## **STAFF REPORT AND RECOMMENDATION TO THE DESIGN COMMISSION**

CASE FILE: LU 13-199812 DZM  
PC # 13-142651  
Glisan Commons Phase II  
REVIEW BY: Portland Design Commission  
WHEN: Thursday December 5, 2013 at 1:30 PM  
WHERE: 1900 SW Fourth Ave., Room 2500A  
Portland, OR 97201

A2.01

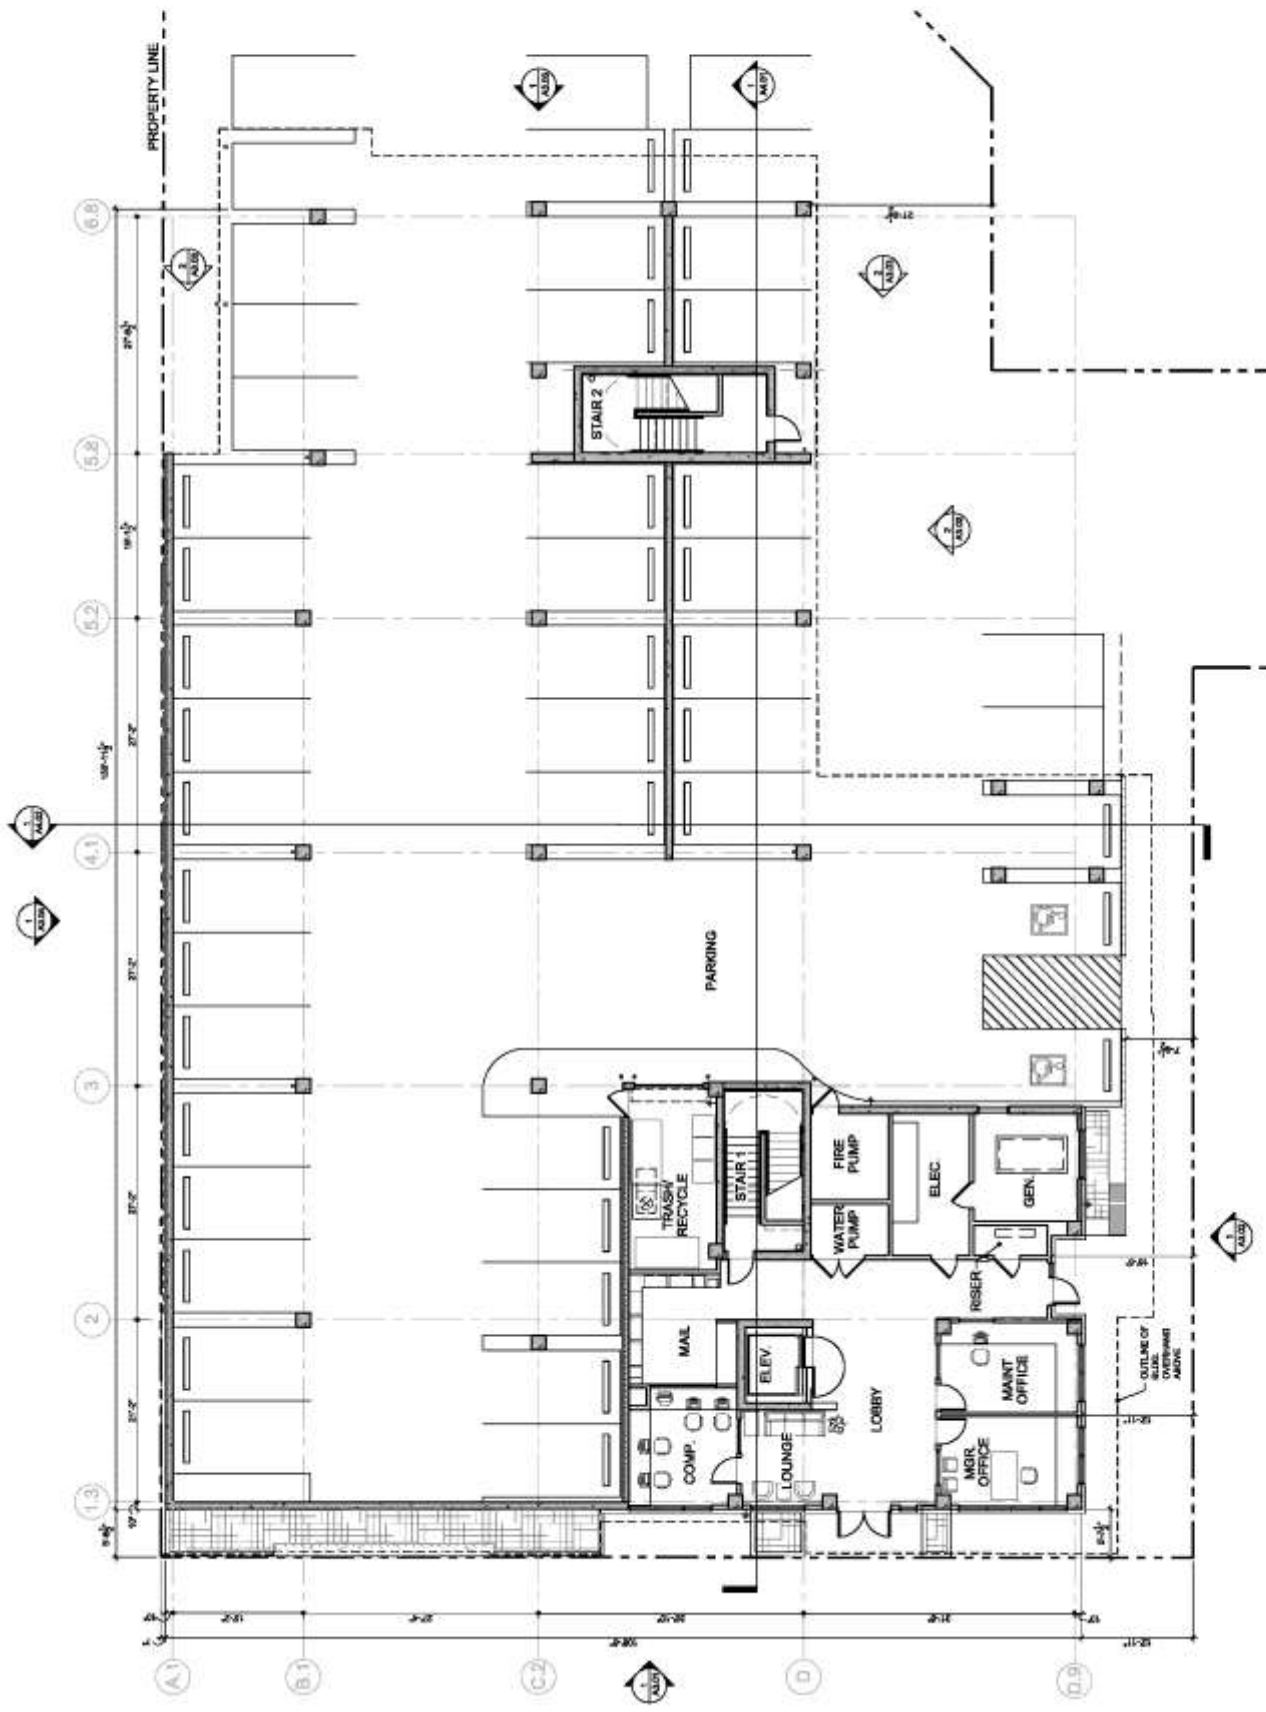
**AREA OF CONCERN #1 – A covered secondary building entry from the covered parking area.**

**Findings:** Additional design consideration should be given to creating a safe and weather-protected walkway that goes from the covered parking area to the secondary lobby entry on the south wall. The current proposal has pulled the 2 ADA parking spaces back by 2 feet from the original proposal so the east-west pedestrian walkway is now a generous 8 feet wide through the site where previously it was pinched down to 6 feet. The proposal now shows a 3 foot deep projecting combination canopy and second floor slab that is continuous from the south lobby door to the edge of the building. This will provide some weather protection to people coming from the covered parking area into the building. However, people must still exit the garage through the shared aisle in between the 2 ADA parking spaces. These spaces may be occupied by vehicles whose users may block the aisle at certain times of the day. Also having an exit in between vehicle spaces may not be as safe as a more direct entry from the garage into the east building wall where the building equipment and other service areas are currently located. One possible design solution is to create a direct entry into the building from the parking area. This would require reconfiguring the ground floor uses and may also result in the loss of a few parking spaces. *With additional design consideration, the proposal could meet the applicable Design Guidelines.*

1. A covered pedestrian walkway from the structured parking to the south building entry or the rear of the lobby;
